APPLICATION NO.	FILING DATE	FIRST NAMED INVENTOR	ATTORNEY DOCKET NO.	CONFIRMATION NO.
10/670,439	09/25/2003	Douglass L. Blanding	86705NAB	5540

Office Action Summary

BLANDING, DOUGLASS L.

FIG. 1

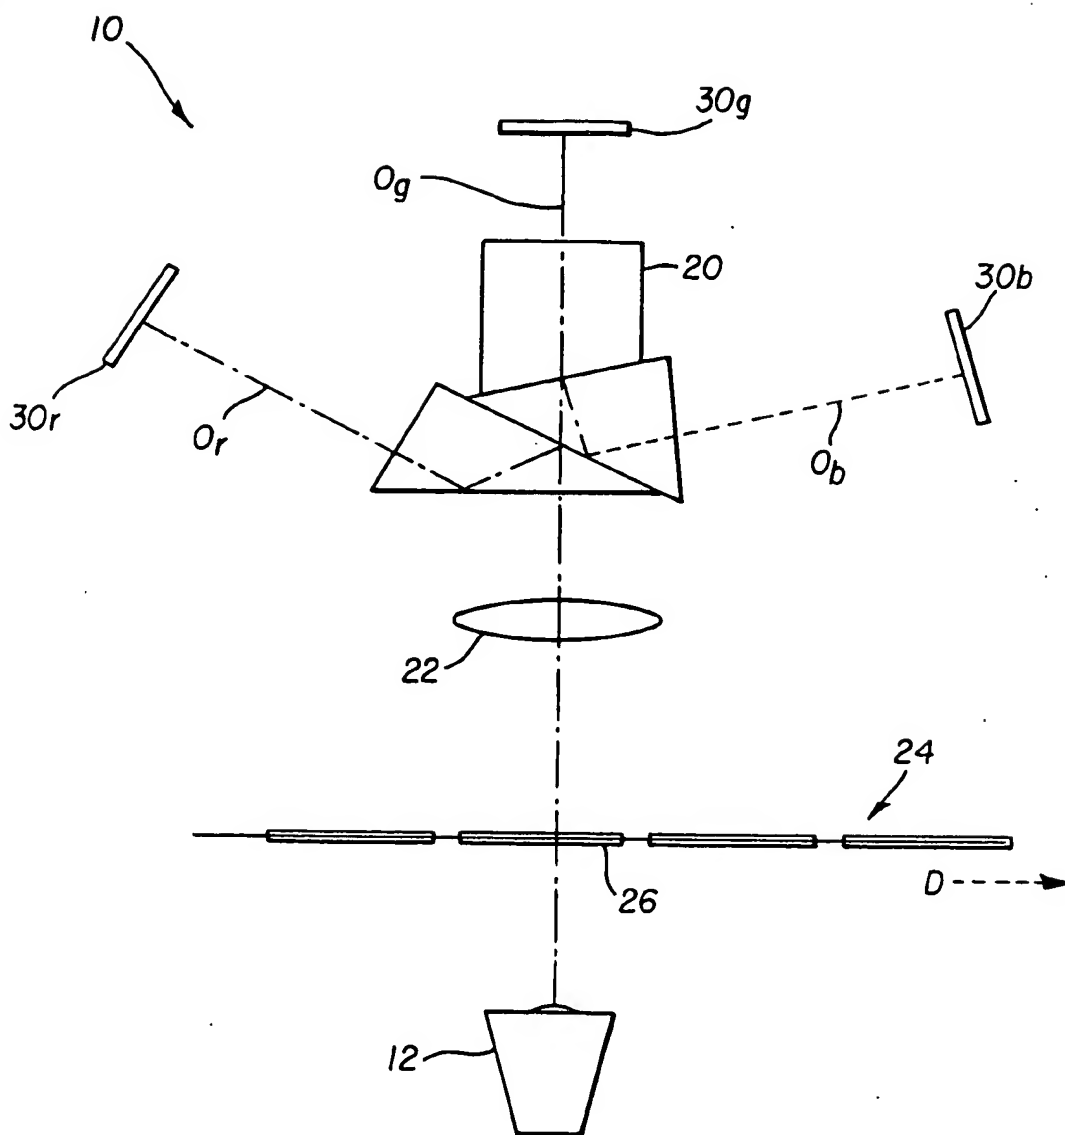
Figure 1 should be designated by a legend such as --Prior Art-- because only that which is old is illustrated. See MPEP § 608.02(g). Corrected drawings in compliance with 37 CFR 1.121(d) are required in reply to the Office action to avoid abandonment of the application. The replacement sheet(s) should be labeled "Replacement Sheet" in the page header (as per 37 CFR 1.84(c)) so as not to obstruct any portion of the drawing figures. If the changes are not accepted by the examiner, the applicant will be notified and informed of any required corrective action in the next Office action. The objection to the drawings will not be held in abeyance.

Acceptable
per
1/27/06
